Proposal for Amendment 1 Phase 2 of the UN Global Technical Regulation No. 7

Submitted by the experts from Japan, Germany and Netherland

The text reproduced below was prepared by the experts from Japan, Germany and Netherland. This document is based on the official document ECE/TRANS/WP.29/GRSP/2018/27 and proposes to remove all the [square brackets] left on this official document ECE/TRANS/WP.29/GRSP/2018/27. All the strikethrough texts and proposed new texts in the original official document are kept on this proposal as it is except for editorial modifications like renumbering of the paragraph numbers, figure numbers, etc.

Figure 98-1

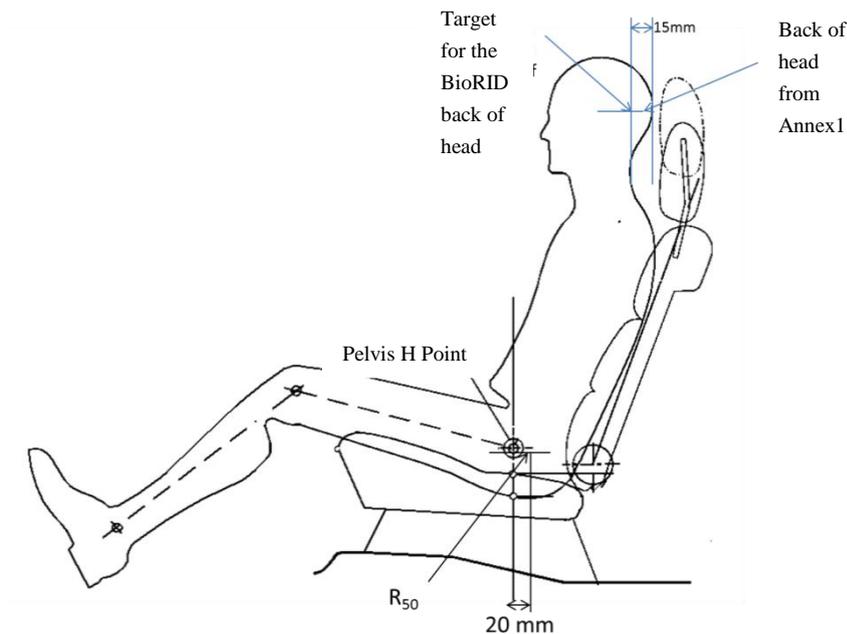
The back of the head reference position for the BioRID II UN is the value for the back of the head as determined for the 50 percentile in table 1 annex 1 of this Regulation with reference to the specified torso angle minus 15 mm (increasing the backset as shown in figure ~~98-1~~*below*).

Figure 98-3
Acceleration versus time curve and Permissible Range of curve for the test set-up according to section 3.2. (The target acceleration with time expressed in milliseconds shall meet the value in the table 98-3.)

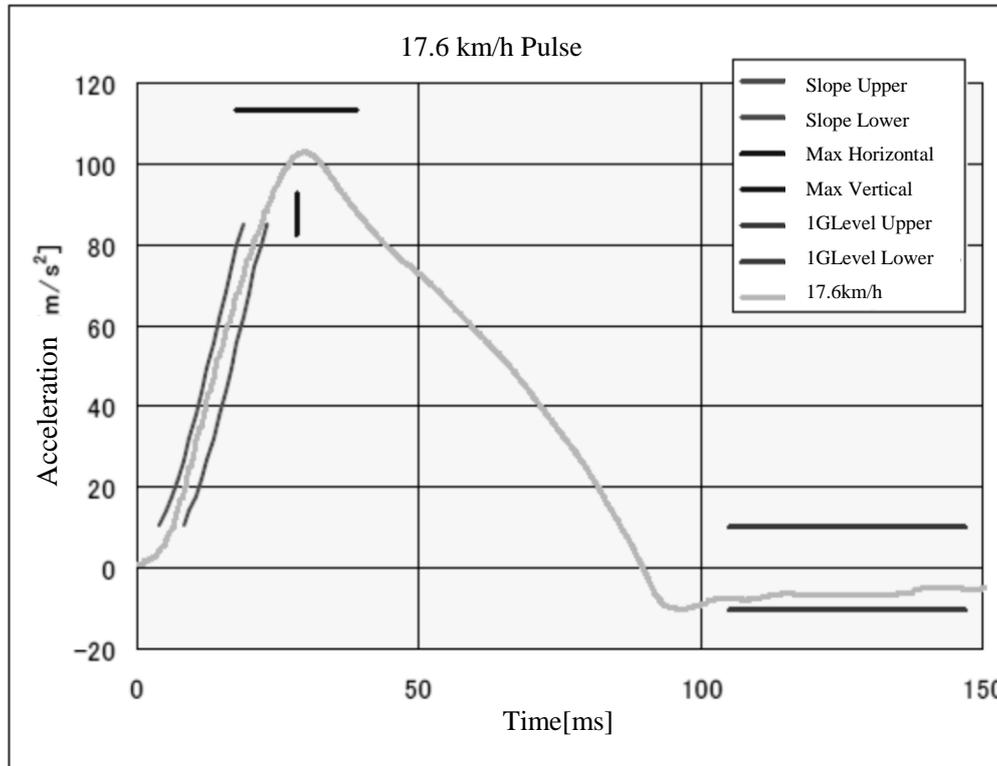
The corridors for the pulse are illustrated in Figure 98-3. The sled acceleration shall be adjusted within the corridors described in Figure 98-3 and Table 98-2 for the complete time interval from 0 to 0.15s. The sled pulse shall fulfil the requirements as specified in Table 98-3.
